EQ-01 SF-S06 / SF-S08 bearings over the FF windows FF-WF02 / FF-WF19 (S-102, S-121)

Dendrons

QUESTIONS FOR THE ENGINEER

Structural queries on the ICF approval drawings - sheet 1 of 1

ICF model (GS-02)

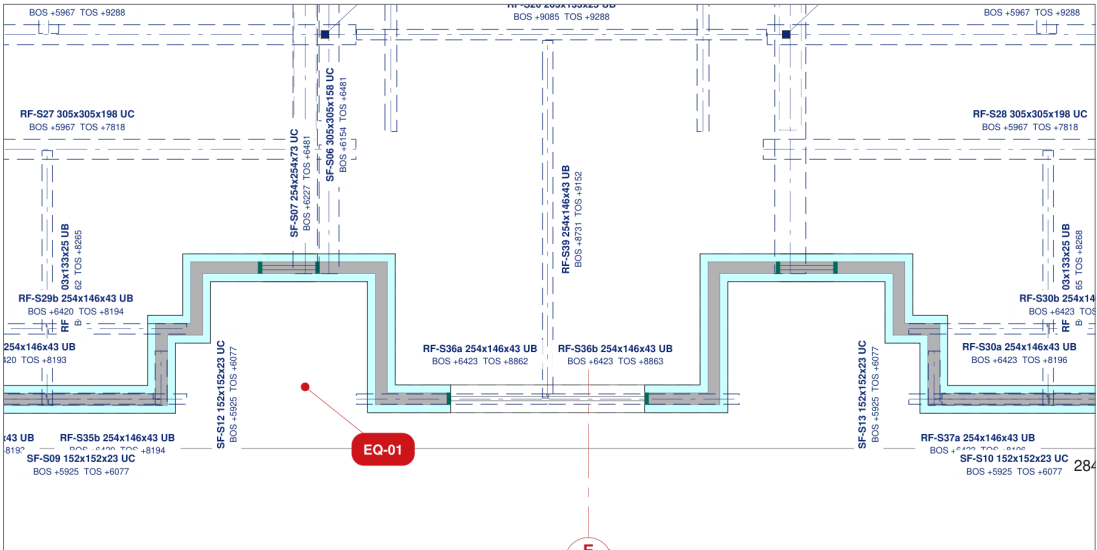
ISSUE The second-floor transfer beams SF-S06 (UC 305x305x158, x 6370) and SF-S08 (UC 356x406x287, x 12586) bear on the south wall (L2, top 174.975 AOD) directly over the 685-wide FF windows either side of the entrance bay. At TOS 175.229 the beam undersides are 6252 (S06) and 6185 (S08) above the slab datum; the architect's window head is 6023, leaving 229 mm (S06) and 162 mm (S08) of wall between head and beam. S-121 schedules an RCB152 x 300 - 2H16 lintel there, which would reach 6323, 71 mm into SF-S06 and 138 mm into SF-S08.

QUESTION Please confirm the bearing detail: a steel spreader under each beam end (model assumption UC 152x152x30, 1285 long, 300 bearing each side, TOS = beam underside), or a revised lintel / beam arrangement. The window positions are the architect's and are held.
